Application from the CNL to amend its Chalk River Laboratories site licence to authorize the construction of a near surface disposal facility

Commission Public Hearing Part 2

Intervention re CNL's Proposed Near Surface Disposal Facility

Dr. J.R. Walker

Near Surface Disposal of Low Level Waste

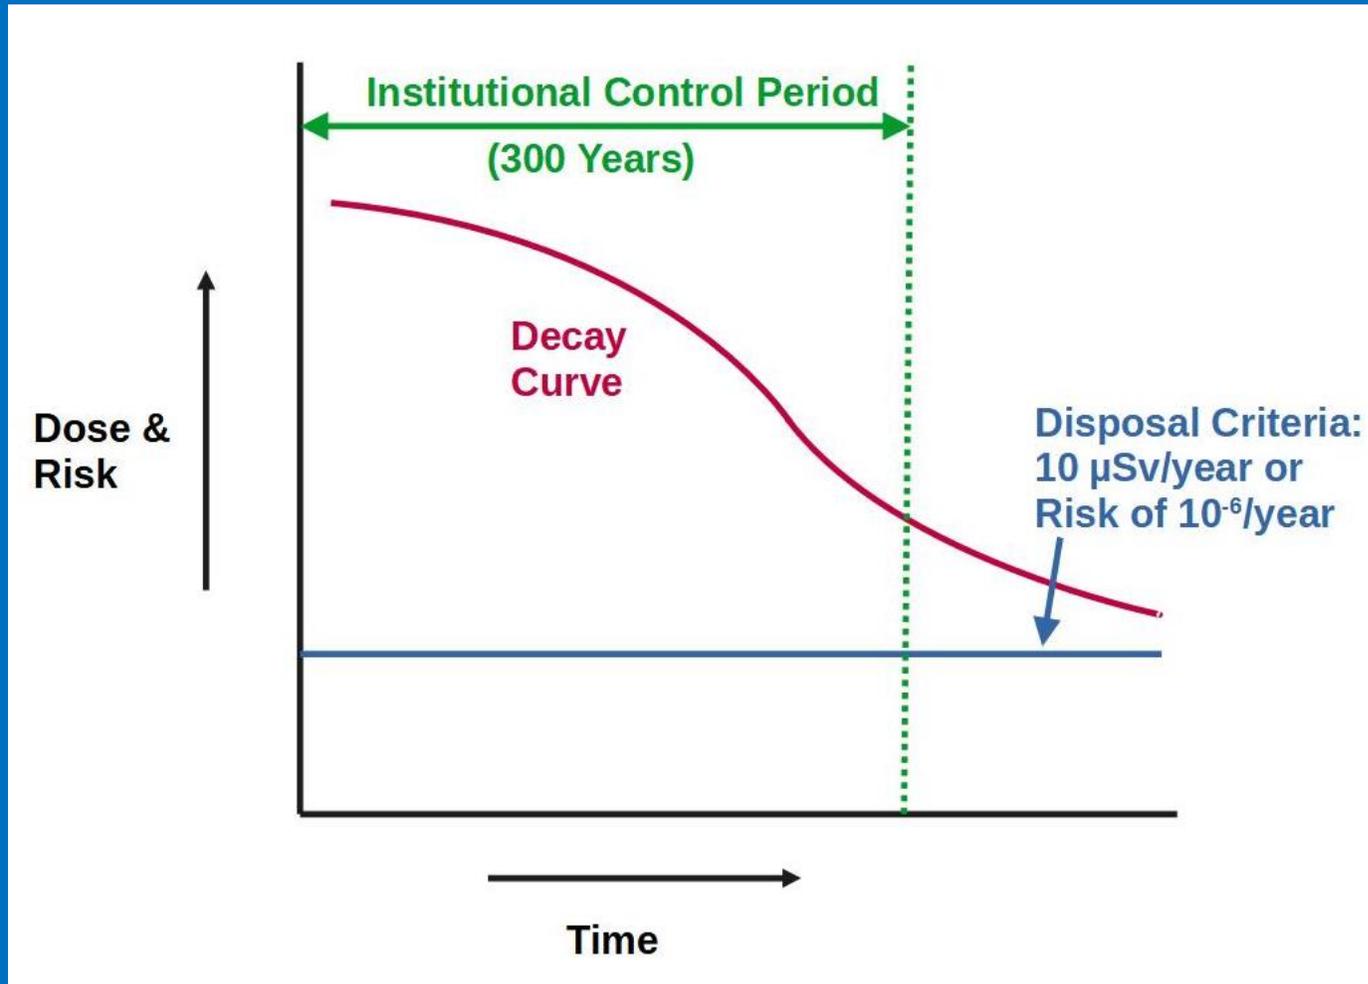
Decay Curve is below the Disposal Criteria by the end of the Institutional Control Period. Hence, emplaced radioactive material is Low Level Waste.
